From: Wolfe, Aaron
Sent: Tuesday, January 31, 2012 7:39 AM
To: Buskirk, Doug
Subject: RE: SCI-823 Phase 1 BMP letter

Re: SCI-823-6.81 (Portsmouth Bypass Phase 1)
Post-Construction BMPs

**BMP SCHEMATIC PLAN - SR823
STA. 335+00.00 TO STA. 390+00.00**

BMP SCHEMATIC PLAN - SR823
STA. 500+00.00 TO STA. 555+00.00

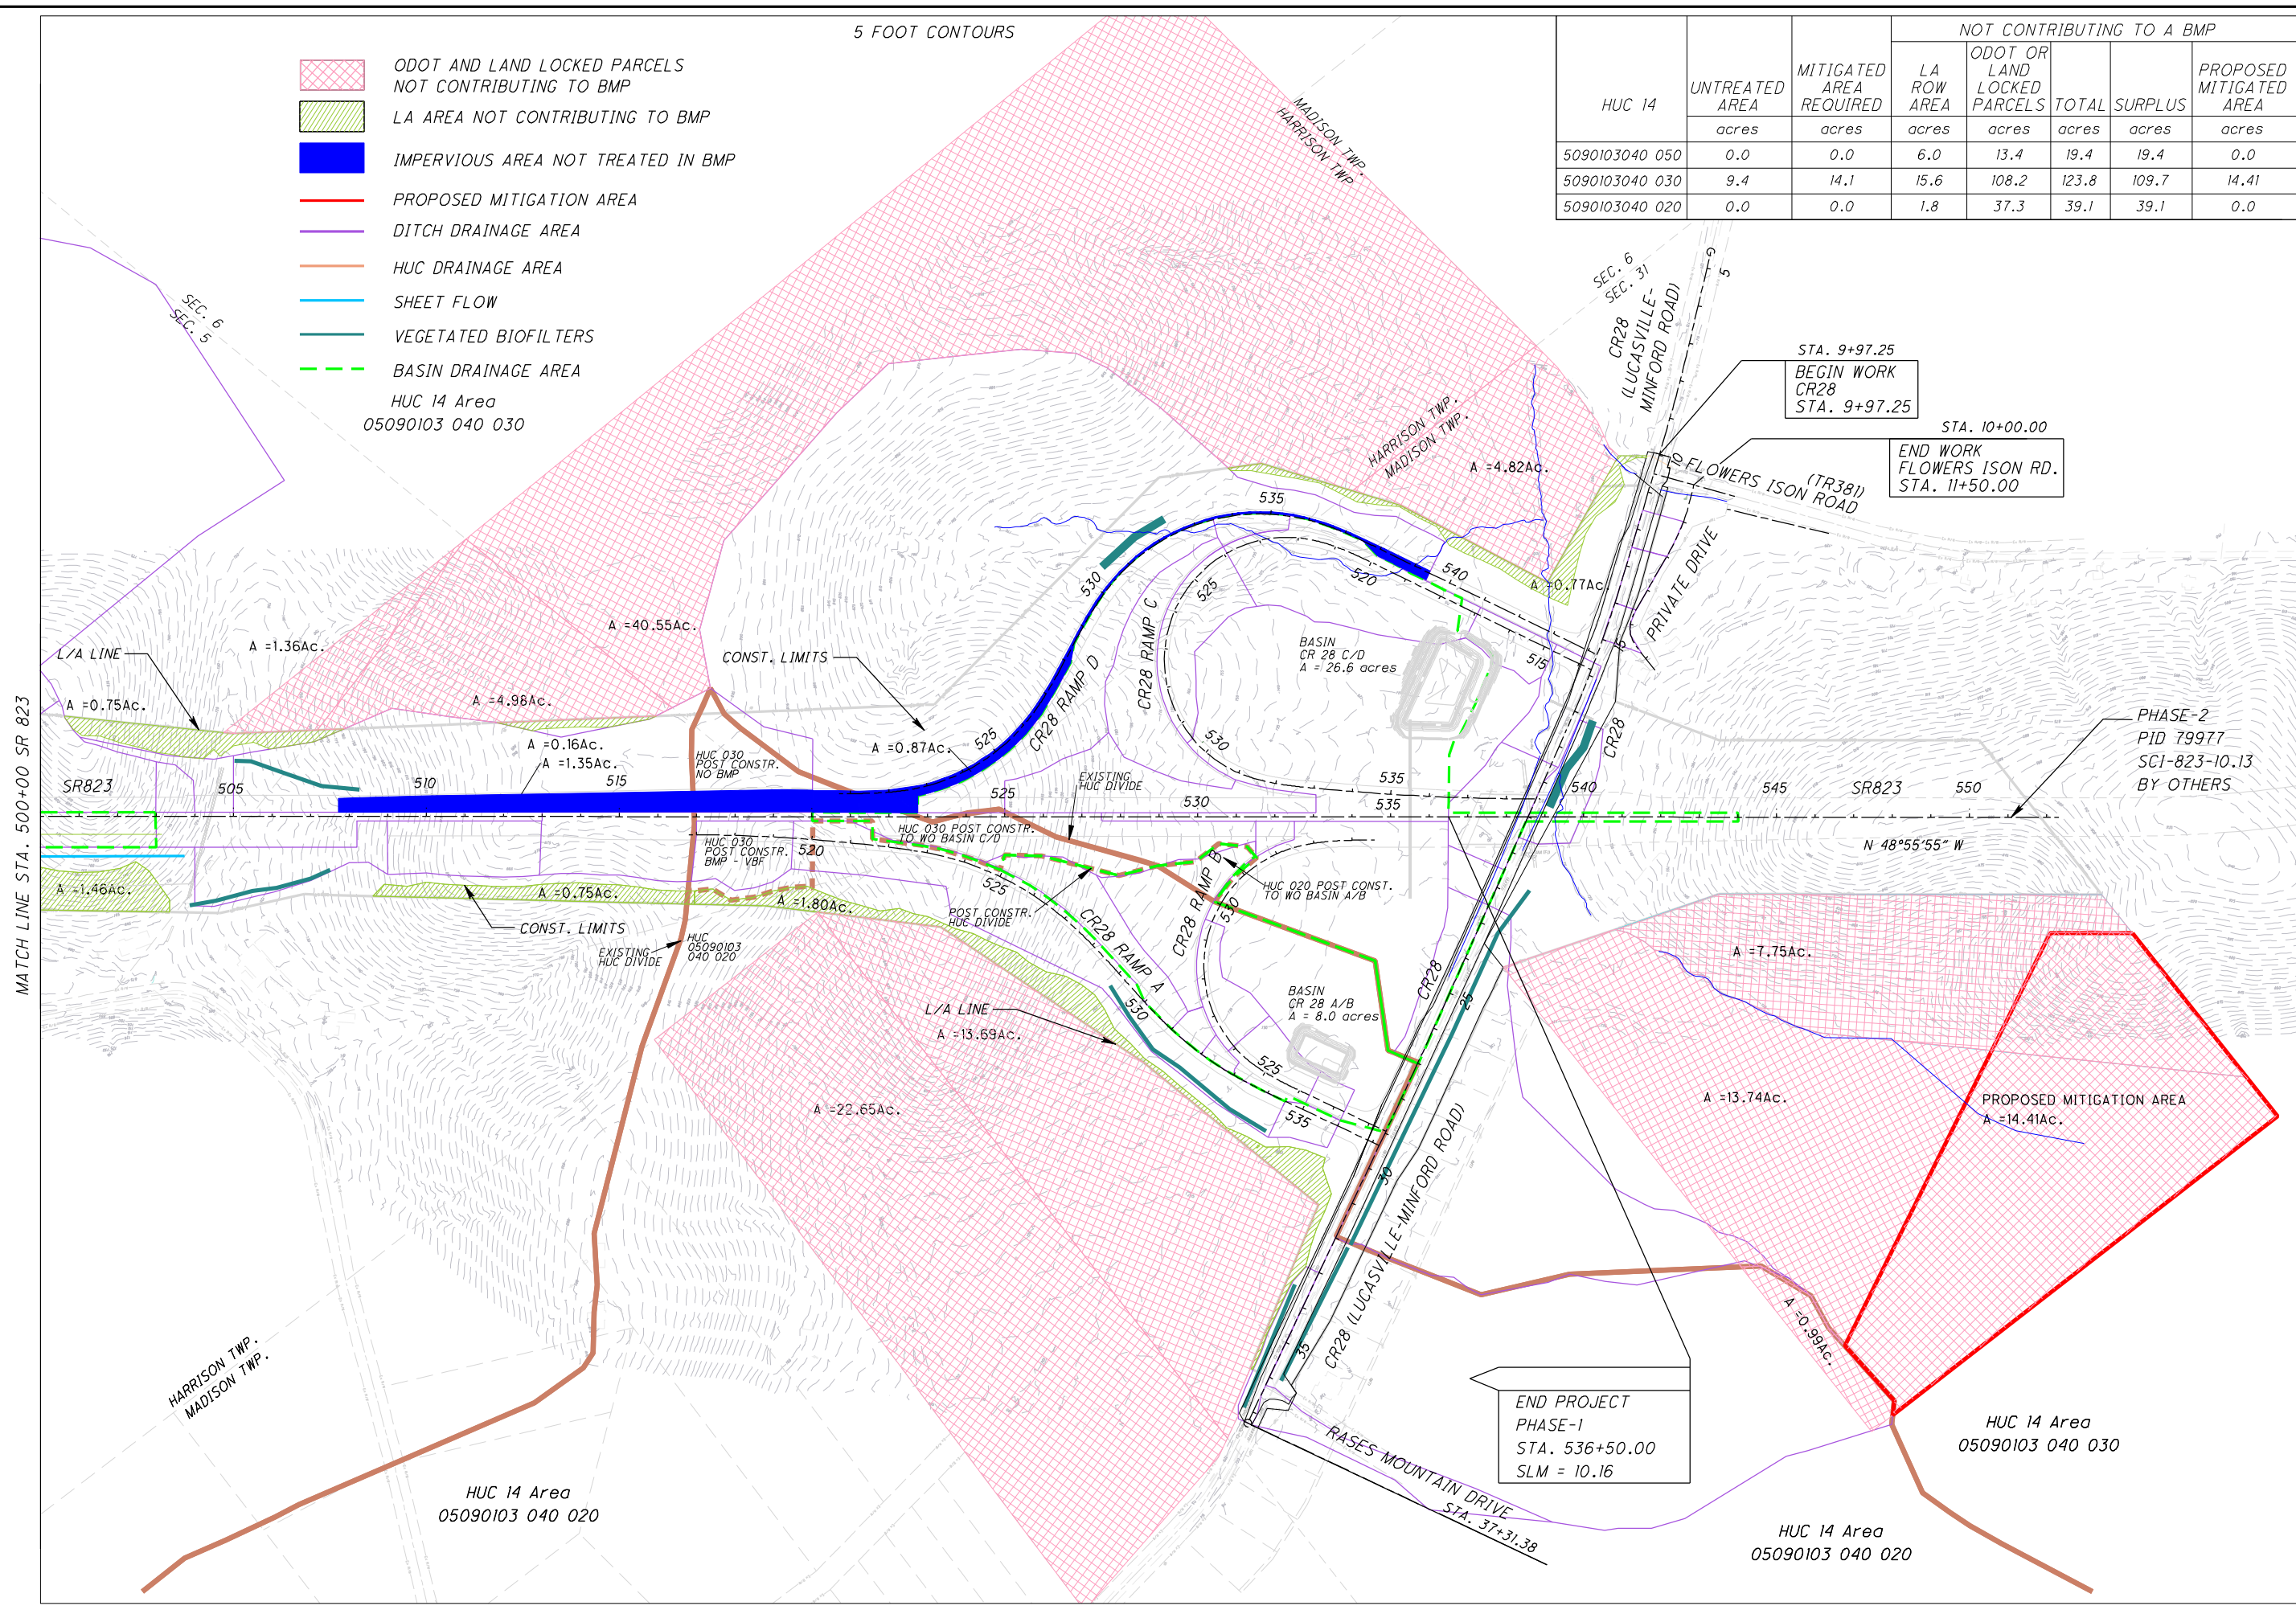
Hello Doug, Everything looks acceptable in concept. However, It would be helpful if you could show what road you plan on access to be made from. I believe I know what is intended but it is a little unclear on the map. Can you show where someone is expected to park and then the direction they would be expected to walk into the mitigation area. It is important that one can get out of the car and walk on ODOT owned land from the car to the mitigation area. That is really the only comment I have everything else looks good. It would be nice if documentation for the easement could be sent to me when its complete. I imagine OEPA will make a database at some point listing these post construction mitigation easements.

If you can submit an updated map with what I have requested above I will get you confirmation of approval.

I have attached right of way sheet 9/41 showing the property owned by ODOT in the mitigation area. As shown on the sheet, ODOT owns up to the right of way for Lucasville-Minford Road, providing access to the proposed mitigation area entirely on ODOT property. It is the intent of ODOT to retain all the property of parcel 504 and 40 for potential future mitigation and access to the proposed mitigation area.

After the construction of the project, access will be provided by parking along the shoulder of Lucasville-Minford road and walking up the valley in the vicinity of the existing field drive to the mitigation area as highlighted on the right of way sheet.

As shown on the attached BMP Schematic Plan sheet, the table shows there is 9.4 acres of untreated area in only one of the three Phase 1 HUC 14 areas, 5090103040 030. ODOT proposes to provide mitigation at a rate of 1.5:1 for a total required area of 14.1 acres. The proposed mitigation area of 14.41 acres is delineated on the Schematic Plan sheet 4. In addition, there is approximately 22.48 acres available for mitigation if needed on the future phases. This area is also delineated on Schematic Plan sheet 4.
